Access Compliance Report

Public Rights-of-Way (Curb Ramps)

Intersection ID: 29950	Main Street: HAMPTON_PLACE_DR	Cross Street: SUTTONVIEW_DR	Location: SE
ADA ID: EE859F6F9246	Ramp Type: PerpDiag	Initial Pass/Fail: Fail	Overall Compliance: No
Severity Score: 10			
Codes/Mitigation Info/Possible Solution		Field Measurements/Component Compliance

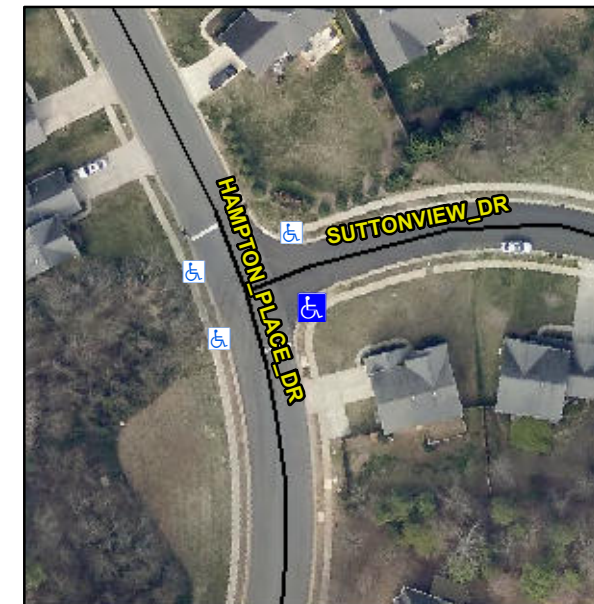
Not Found, R304.5.1, R304.5.3

Compliance	Description	Data	Compliance	Description	Data
N/A	Ramp Length (in)	51.5	Yes	Ramp Slope (%)	6.8
No	Ramp Width (in)	47.0	No	Ramp XSlope (%)	4.7
N/A	Flare Type LT	N/A	N/A	Flare Type RT	N/A
N/A	Flare Slope LT (%)	N/A	N/A	Flare Slope RT (%)	N/A
N/A	Flare Traversable LT?	N/A	N/A	Flare Traversable RT?	N/A
N/A	Landing Length (in)	N/A	N/A	DWS Provided?	N/A
N/A	Landing Width (in)	N/A	N/A	DWS Contrast?	N/A
N/A	Landing Slope (%)	N/A	N/A	DWS Length (in)	N/A
N/A	Landing X Slope (%)	N/A	N/A	DWS Full Width?	N/A
N/A	Landing Curb? (Y/N)	N/A	N/A	DWS Offset (in)	N/A
N/A	Shared Landing?	N/A			
N/A	Gutter Ponding?	N/A	N/A	Gutter Slope (%)	N/A
N/A	Gutter Lip Ht (in)	N/A	N/A	Gutter X Slope (%)	N/A
N/A	Painted X Walk1?	No	N/A	Painted X Walk2?	No
	X Walk 1 Direction	To N		X Walk 2 Direction	To W
N/A	X Walk 1 Width (in)	N/A	N/A	X Walk 2 Width (in)	N/A
	X Walk 1 Slope (%)	4.5		X Walk 2 Slope (%)	2.7
	X Walk 1 X Slope (%)	5.1		X Walk 2 X Slope (%)	0.8

Remove & Replace Curb Ramp With Two New Directional Ramps or Equivalent.
